**AGENDA**  
**Middleton Planning & Zoning**  
**Commission Meeting**

1. Consent Agenda (items of routine administrative business)
  - a. Consider approving January 10, 2022 regular meeting minutes.
2. **Public Hearing:** Application by Wade Thomas/IAG Capital, LLC, and Bob Unger for preliminary plat with respect to The Mill at Middleton Subdivision located at 0 N. Dewey Avenue (Tax Parcel Nos. R33892, R33888, and R33876). The proposed preliminary plat consists of 50 residential lots and 10 common lots on 16.71 acres of vacant land zoned R-3 (single family residential). – Roberta Stewart
3. Consider approving the written Findings of Facts, Conclusions of Law and Recommendation (FCR) for The Mill at Middleton Subdivision. – Roberta Stewart

## PLANNER COMMENTS – Carlton Meadows South Preliminary Plat

## Engineering & Planner Comments

SHEET NO:  
**Preliminary Plat**

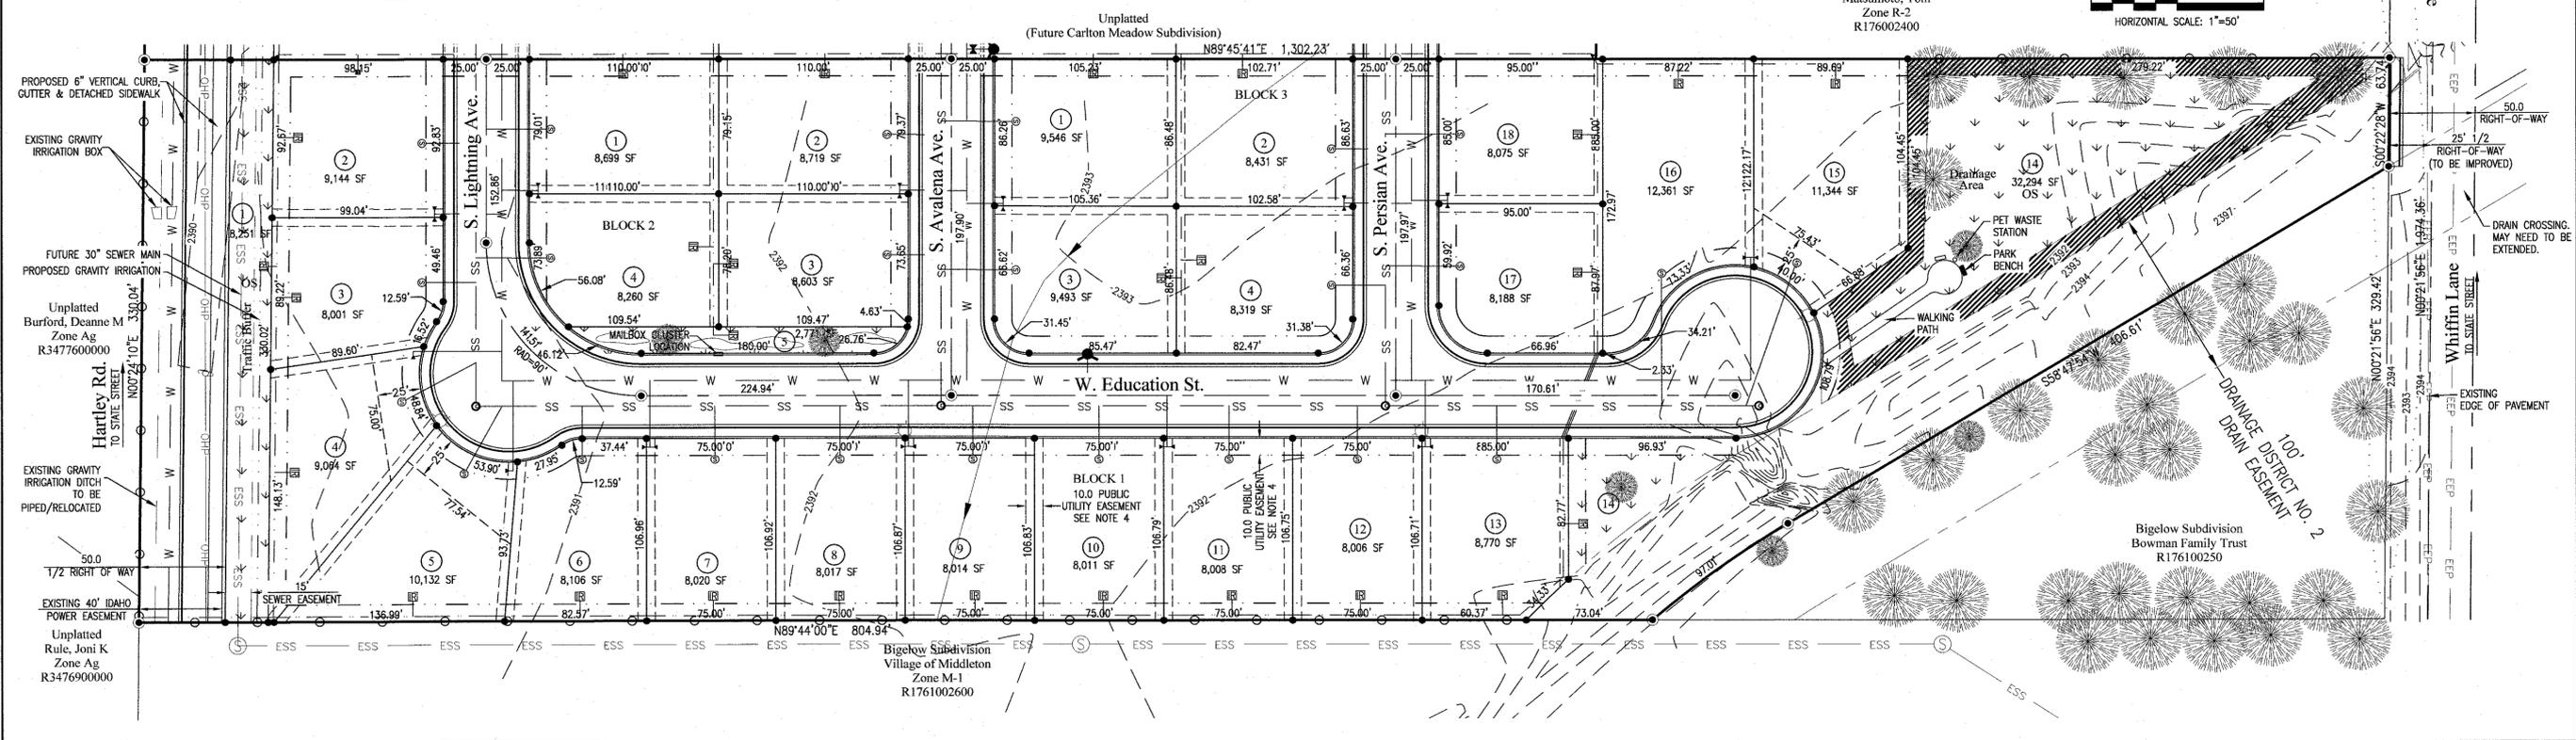
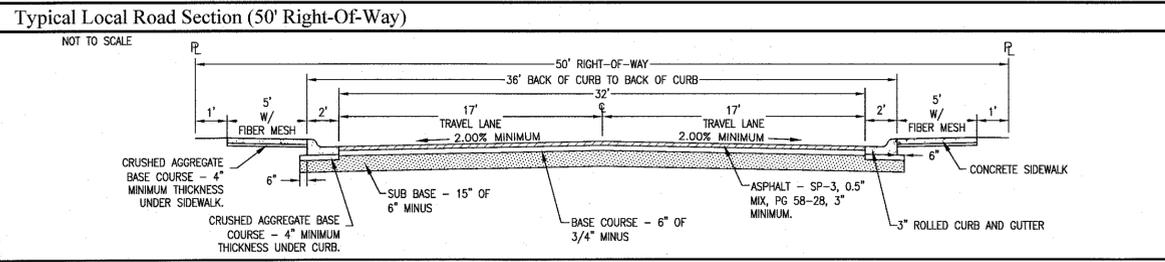
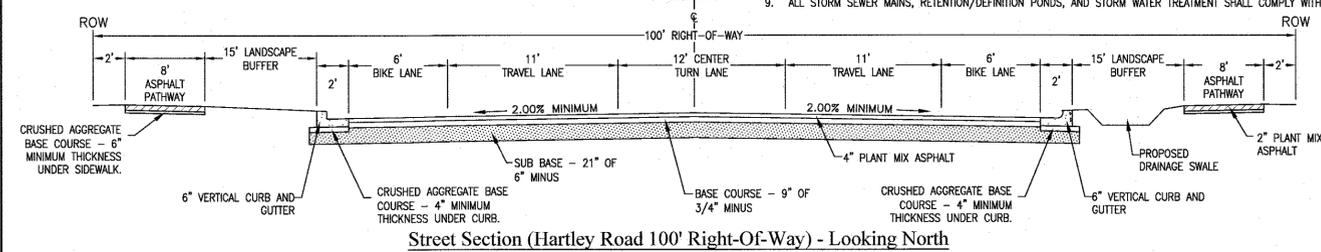
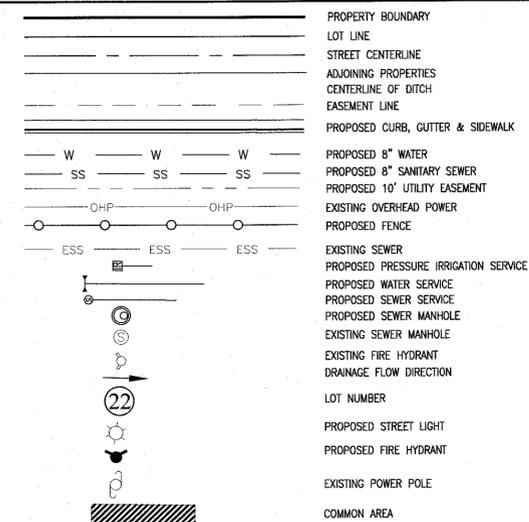
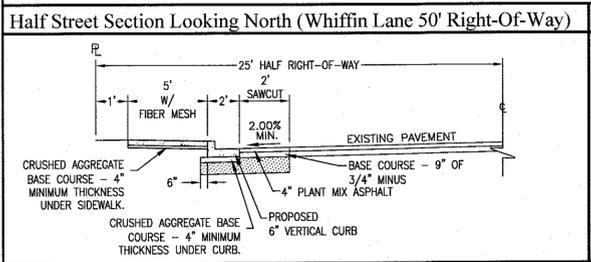
- What is status of the southeast corner - south of the drain? If split off, please provide the documentation. If not, the property may be eligible for a one time division or please include it in the subdivision boundary.

- 3) MCC 5-4-4.2.f. and g. Need to show the topography in addition to contours.
  - Include Whiffin, drains, trees, utilities, benchmark, etc.
  - Identify the drain crossing on Whiffin and note it may need to be expanded.

- Dimension the existing right of way for Whiffin – identify area being dedicated.
- 4) Show fully the water in Hartley.
- 5) Label/identify all easements - existing and proposed. Include Hartley sewer.

- 6) Note 4. Identify purpose of side lot line easement: utility, irrigation, etc.
- 7) Note 7. *Most current* edition of ISPWC
- 8) Note 8. Add language: Carlton Meadows will extend streets and all utilities to the north boundary of Carlton Meadow South. If the street and utility extensions in Carlton Meadows are not completed, Carlton Meadow South will be reconfigured to meet City Code as required.

- 9) Note if project is in floodplain.
- 10) Add note: No direct access to Hartley.

- 11) Add note: Exterior boundary to be fenced per approved fencing plan.
- 12) Show the irrigation system layout.
- 13) Lot 15/Lot 16 both need a sewer service. Extend sewer main east and take service to main if possible, not manhole.
- 14) Show Hartley in plan view including curb and pathway. Identify the location of power structures.
- 15) Clearly show the landscape easement area.
- 16) Show hydrant location.
- 17) Show location of mailbox cluster or note included in Carlton Meadows or?
- 18) Correct street names. Street is east/west. Avenue is north/south.
- 19) Centerline radii is 90ft minimum.
- 20) The stormwater management area is 1 to 2 ft higher than the west end of the project. Understand the site may be filled or other – please note it almost always becomes a problem when the topography doesn't closely follow the project layout.

1. Show perimeter fence around development.
2. Note 4. City code only requires 5 ft wide utility easement on interior lot lines
3. Show right of way and utility easements within right of way. Call out in notes.

4. Add note the project will be developed in one phase.
5. Call out dimensions for L4/B1, L5/B1, L15/B1 of frontage at 25 ft setback. Needs to be at least 75 ft.

6. Work with City Engineer - Roads need to show a turning radius of minimum of 90 ft. Call out in notes.
7. L1/B1 is not considered open space. It is a landscape buffer, but still maintained by the HOA. Please revise the Open space area and percentage.

9. It would be nice if you could add an amenity such as a bench or shade structure in common space.
10. Add note to call out common areas by lot and block and state who owns and maintains them.

11. Add note: All lots are residential building lots except lots (insert L/B)
12. Add cluster mailbox(s) in common area(s). Call out in notes.
13. MCC 5-4-10 (2J) "roads having a predominantly north-south direction shall be avenues; roads having a predominantly east-west direction shall be streets., and cul-de-sacs shall be courts." Change Street names accordingly. (I am verifying your proposed road names with Canyon County, there may be some changes)

1. Show perimeter fence around development Add note to explain how it ties into the Carlton Meadows Subdivision to the north.
2. Note 4. Change to the following: “All lot lines common to public Rights-of-Way and the exterior subdivision boundary or rear boundary line of lots shall have a 10’ wide permanent public utilities easement, unless otherwise shown. However, this easement shall not preclude the construction of proper hard surfaced driveways for access to each individual lot. A 5’ wide public utility easement shall be on all interior lot lines.”

3. Show Open Space square footage in the common lots. It looks like only Lot 14/Block 1 will be able to be used as a common, greenspace lot.
4. Please add a small walking path (crushed granite, asphalt, etc) and perhaps a few benches and a pet waste station to make the large part of Lot 14/Block 1 usable as a gathering space. See attached drawing (Obviously not to scale).

5. Please revise the Open space area and percentage in table. If the Open space is not at least 5% you will have to get a license agreement from the ditch company to gain access on their easement.

6. Remove Key with setbacks and maximum building height.
7. Revise Landscape plan to show trees and/or shrubs in common areas
8. Address any additional comments from City Engineer, MRFD, CHD4, ITD, Irrigation District.

1. Add to note 4 " All lot lines common to Public Rights-of-Way and the Exterior Subdivision Boundary **or Rear Boundary Line ...**"
2. Call out the Open Space area with hash marks and in the legend so that the actual square footage of the lot is easily identified.
3. Revisit the Landscape Plan and add a few more trees where it makes sense for privacy of adjacent lots to the common area.

PRELIMINARY PLAT SHOWING  
 THE MILL AT MIDDLETON SUBDIVISION  
 LOCATED IN THE SE 1/4, OF  
 SECTION 6, T.4N., R.2W., B.M.  
 CANYON COUNTY, IDAHO  
 2022

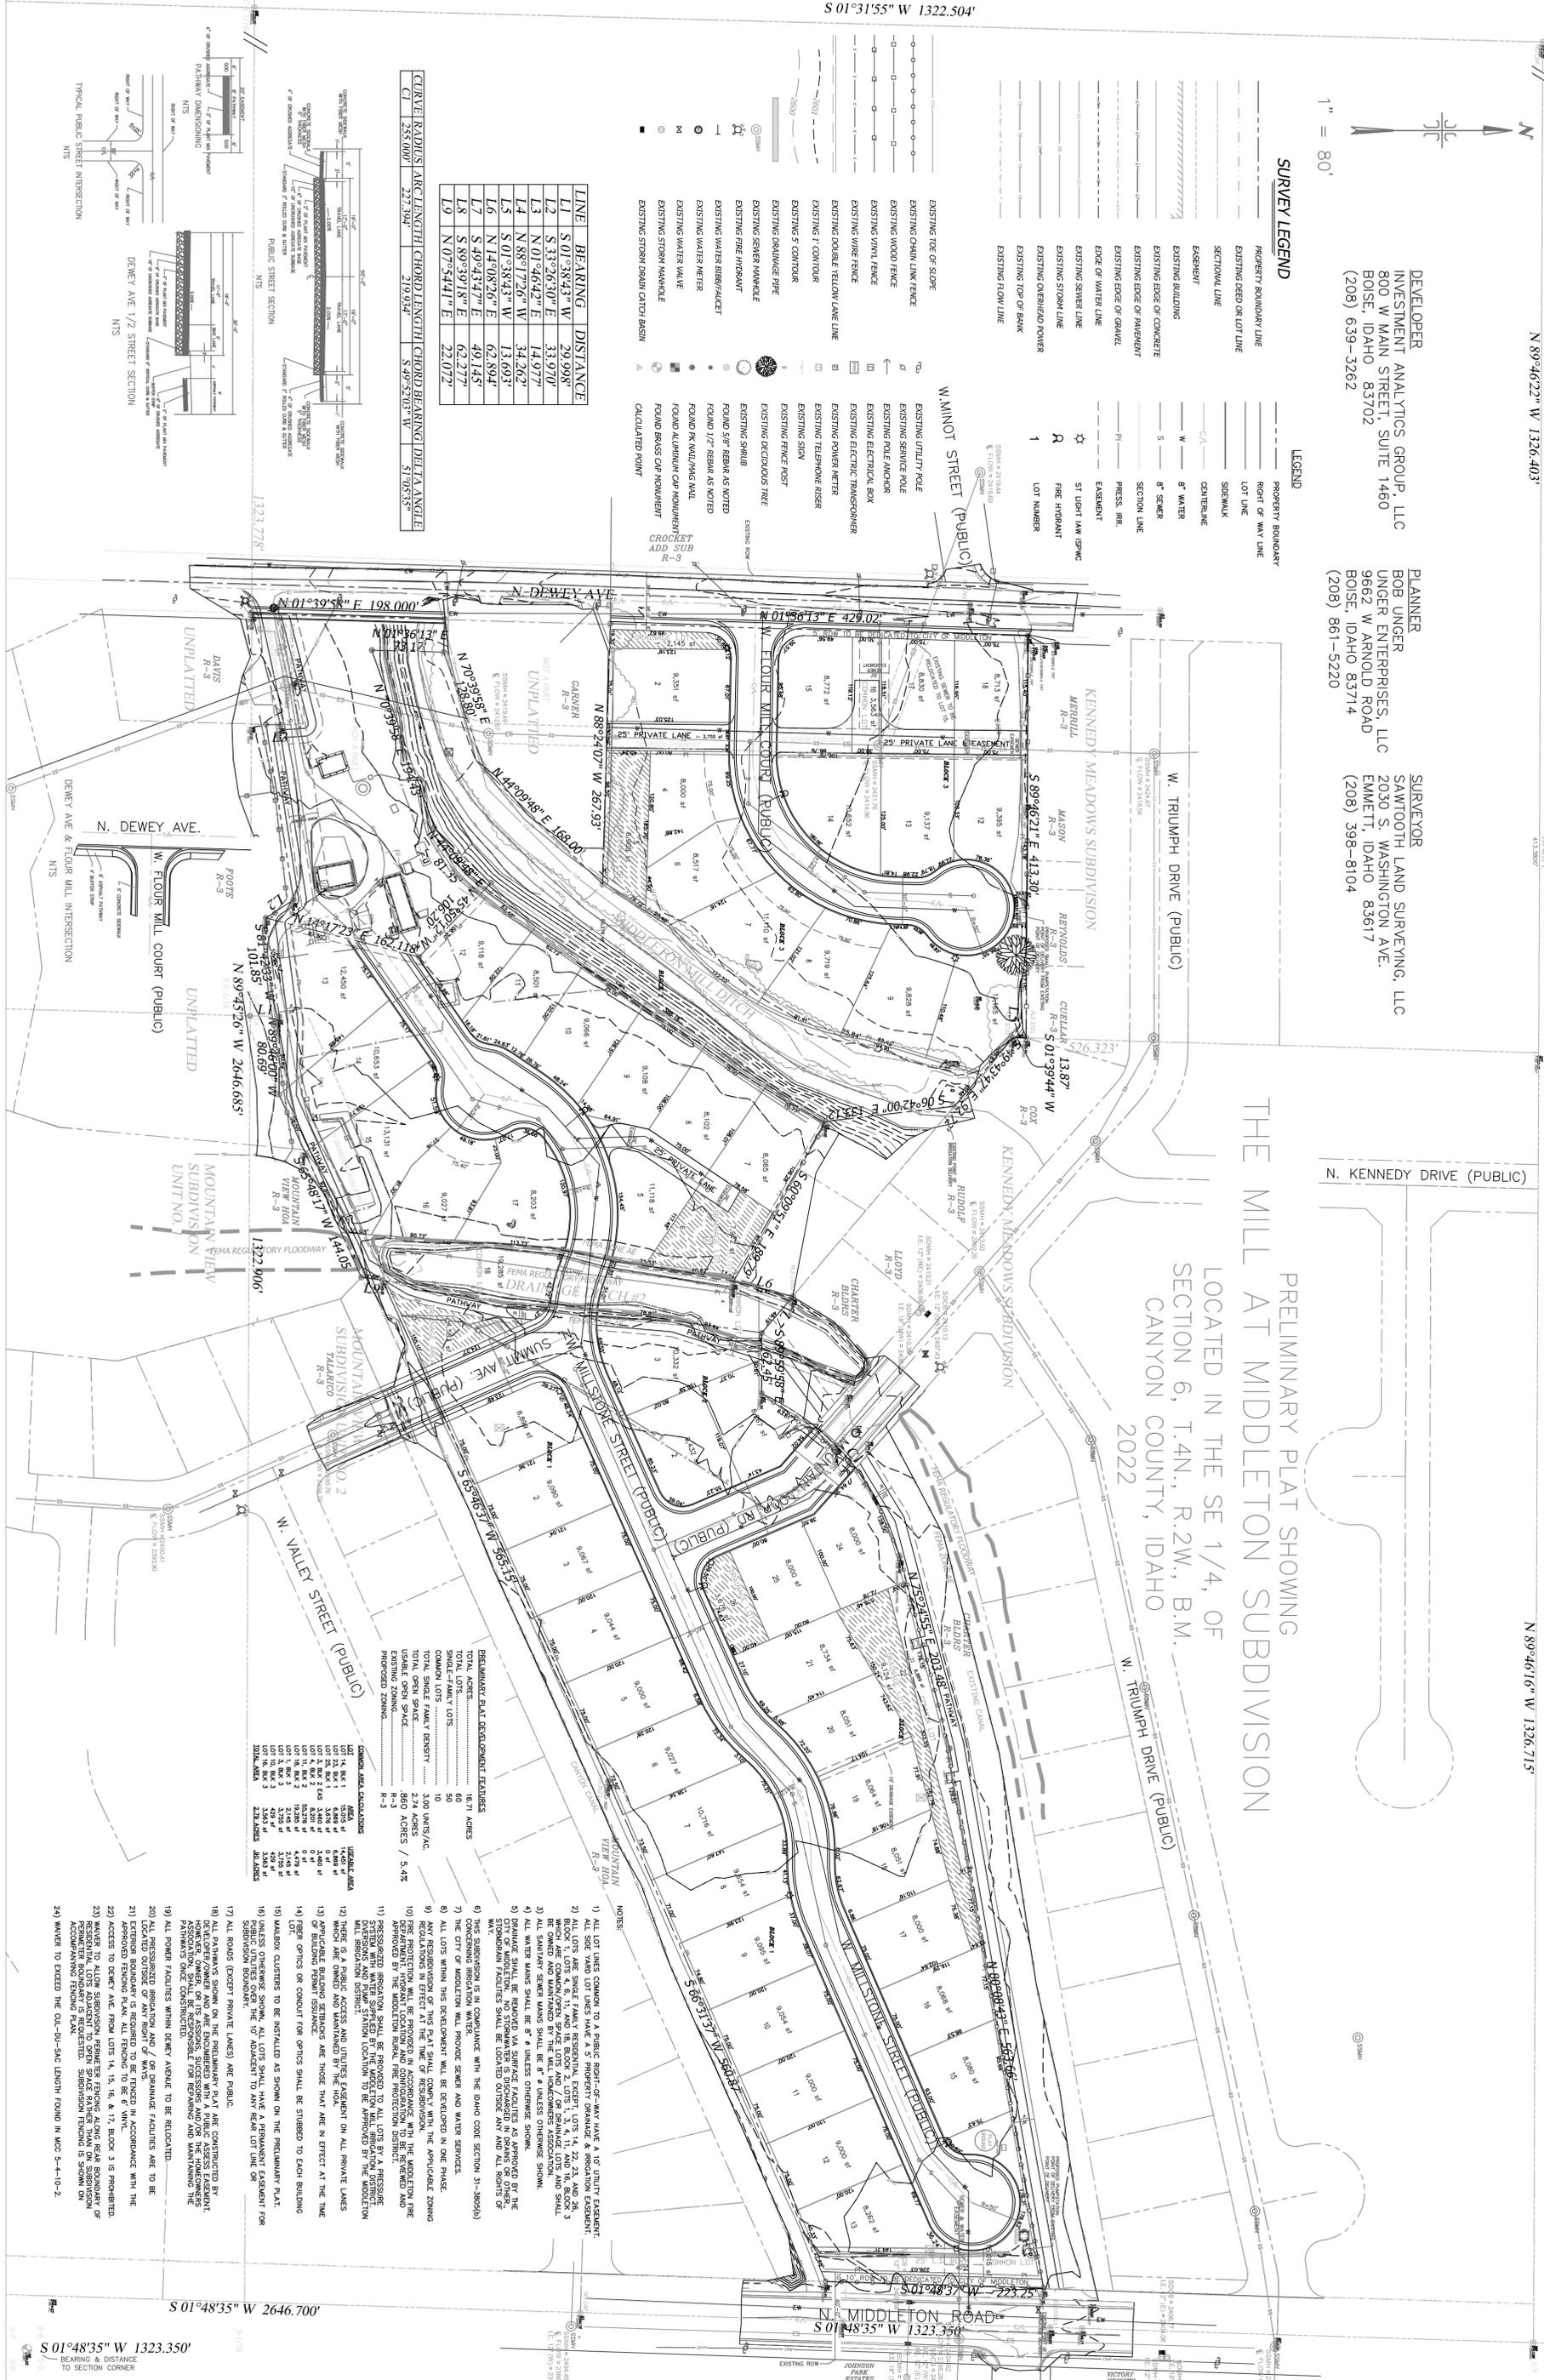
MCC 5-4-4.2. a. Please add bearing and distance to section corner, quarter corner or monument of record.

MCC 5-4-4.2. c. Adding phasing plan if applicable or note all lots developed in one phase.

MCC 5-4-4.2. f. Revise topography to clearly show existing.

1. Either eliminate lines (assumed existing) or label.
2. Dimension and clearly identify every lot.
3. Please use 2ft contours and label them.
4. Add benchmark information.

1. Show Canyon Canal along the south boundary, including topography.
2. Show existing irrigation infrastructure for parcels and relocation if applicable.

1. Dimension existing rights of way and clearly label/name.
2. Show improvements on Dewey clearly and how proposed frontage area will transition to existing. Include stormwater management.
3. Dimension right of way for Dewey.
4. Show existing easements including for "Existing Canal Drainage Ditch #2" and Middleton Mill.
5. Add note or callout power in Dewey to be relocated.
6. Show Minot Street intersection and label.
7. Mountain Loop Road (not legible) right of way to be consistent to the intersection with Millstone Drive.
8. Is the sewer easement 30ft or 20ft? Show the easement.
9. Label Middleton Road right of way and additional width to be dedicated.

10. What is the ownership of the private lanes? If separate lot, label accordingly. If easement area then also dimension and clarify.

1. Add a note addressing installation of fiber optic network.
2. Add note hydrant location and configuration to be reviewed and approved by Middleton Rural Fire Protection District.

1. Review the sewer crossing at Summit (profile) and verify there is sufficient depth and separation from the bottom of the canal per the irrigation or drainage district with jurisdiction.
2. What is the purpose of new 20ft sewer easement between lot 16 and lot 14, block 3.

3. Water corridor is north and east, sewer is south and west.
4. Please plan to connect to the existing water main at the intersection of Middleton Road, at Summit and at Mountain Loop.
5. Connect to Middleton water main at 90d and add three valves.
6. Show the existing water in all streets and in private lanes. How will utilities be extended to lots and is there separation per IDAPA?

1. Stormwater. Plan to manage a 100 year/1 hour storm using retention facilities only. No subsurface. The front half of the lot C value is 0.60, the rights of way/impervious (all) are 0.95 – use a composite of both. All stormwater management facilities require pretreatment, all infrastructure to be shown on preliminary plat. Stormwater facilities are owned by HOA and the provisions for maintenance laid out in CCRs. Identify lots to be used for stormwater management
2. Note 5. No discharge of stormwater from rights of way.

Add note detailing all irrigation and/or drainage to be relocated out of rights of way.

Note 6. Expand to address Idaho Code 31-3805(b). Show the irrigation system layout and point of diversion/pump station location. Combine with Note 11.

Note 7. City of Middleton will provide sewer and water service.

Note 8. Delete

Note 12. Add public utility to the easement purpose.

Note 19 and Note 20. Delete.

Add a note regarding fiber.

Add a note: exterior boundary is required to be fenced in accordance with approved fencing plan. Remove perimeter fence callout or add it to the landscape plan.

Correct street names. Street is east/west. Avenue is north/south. Cul-de-sac is Court.

Add centerline radii and intersection radii.

MCC 5-4-4.2. a. Please add bearing and distance to section corner, quarter corner or monument of record.

MCC 5-4-4.2. f. Revise topography to clearly show existing.

1. Either eliminate lines (assumed existing) or label. Dewey/Middleton and local streets.
2. Dimension and clearly identify every lot. Make dimensions larger. They are not legible.
3. Please use 2ft contours and label them. Labels are not legible.
4. Add benchmark information.

1. Show Canyon Canal along the south boundary, including topography.
2. Show existing irrigation infrastructure for parcels and relocation if applicable.

1. Dimension existing rights of way and clearly label/name. Middleton Highway District does not exist. City of Middleton only.
2. Show improvements on Dewey clearly and how proposed frontage area will transition to existing. Include stormwater management. Add a typical section.
3. Dimension right of way for Dewey.
4. Show Minot Street intersection and label. Label all existing streets on the plat.
5. Mountain Loop Road right of way to be consistent width to the intersection with Millstone Drive.
6. Show the sewer easement per the record. The sewer easement near the north boundary of Lot 11 Block 3 is not approvable as shown. The east limits are too narrow.
7. Label Middleton Road right of way and additional width to be dedicated. Middleton Highway District does not exist. City of Middleton only.
8. Text is not legible on private lanes.

1. Review the sewer crossing at Summit (profile) and verify there is sufficient depth and separation from the bottom of the canal per the irrigation or drainage district with jurisdiction and the City. **You need to submit bottom of ditch elevation and top pipe elevation and verify the sewer can be installed as shown.**
2. Also evaluate Drainage Ditch 2 the same way.
3. For the sewer relocation: the sewer easement is not approvable as shown. Need at least 10ft min on offside.

4. Water corridor is north and east, sewer is south and west. Review IDAPA and revise linework to provide at least 10ft of separation between water and sewer. Water and sewer are in roadway, not under curb/gutter.
5. Connect to Middleton water main at 90d and add three valves.
6. Clearly show existing water in Dewey and new water in culdesac. Add valves.
7. Three valves at tee, four valves at cross, typical of all.
8. Label existing water and show where existing connects to new.
